# TECHNICAL TRAINING POINTER

W10405379  
March 2011

## Crosley, Maytag and Whirlpool Top Load Washers Design Change/ Elimination of Counter Weight

Figure 1

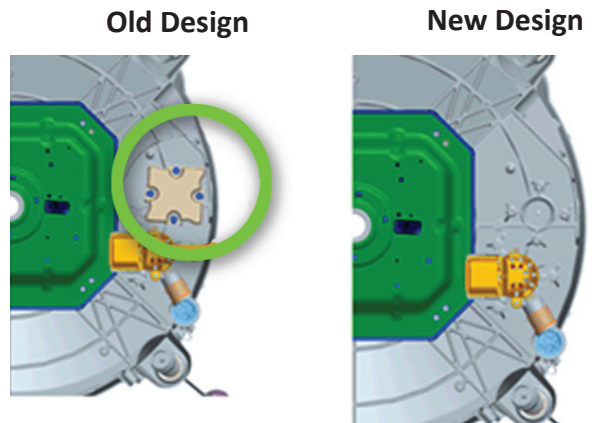
The counter balance weight is being eliminated, see figure 1.

Figure 2

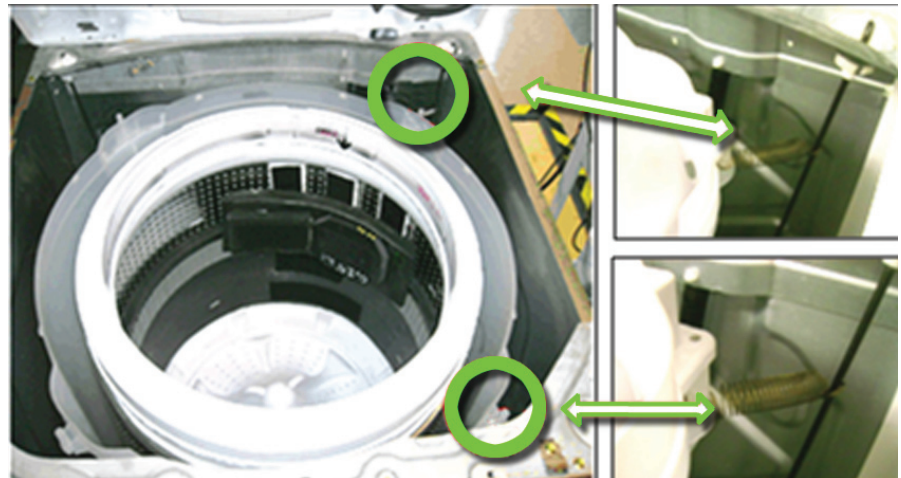
Two small tub centering springs that secure to the upper tub bosses on the right side and suspension rods have been added, see figure 2.

Figura 1

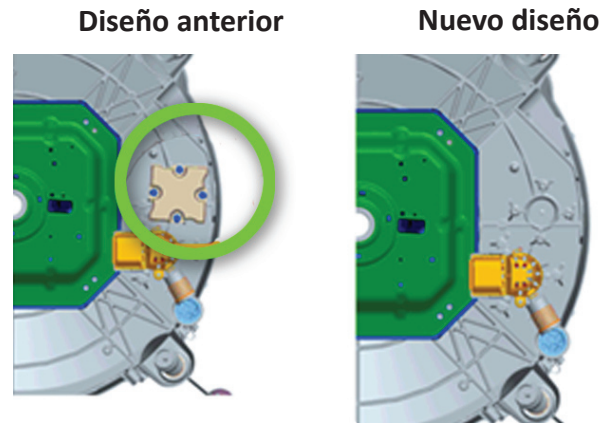
El peso de compensación ha sido eliminado, vea la figura 1.

Figura 2

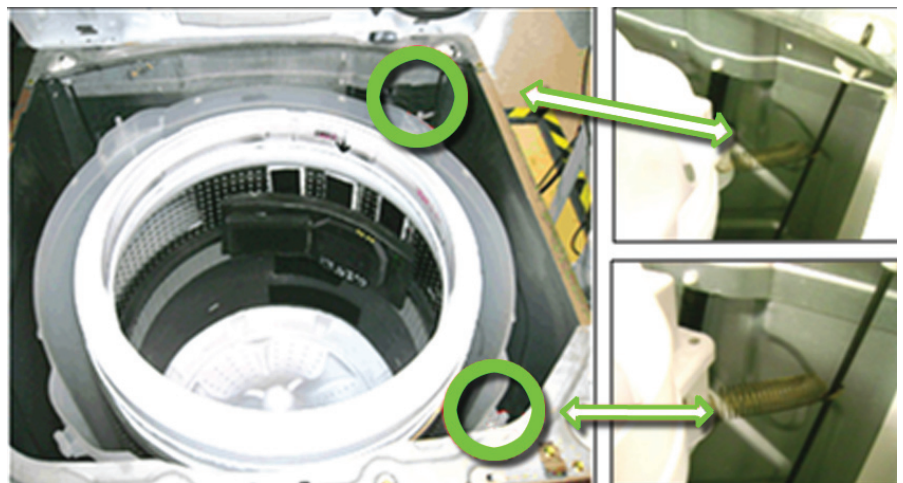
Se han agregado dos resortes pequeños de centrado de la tina, que se fijan a los salientes superiores de la misma en el lado derecho, y bielas de suspensión; vea la figura 2.
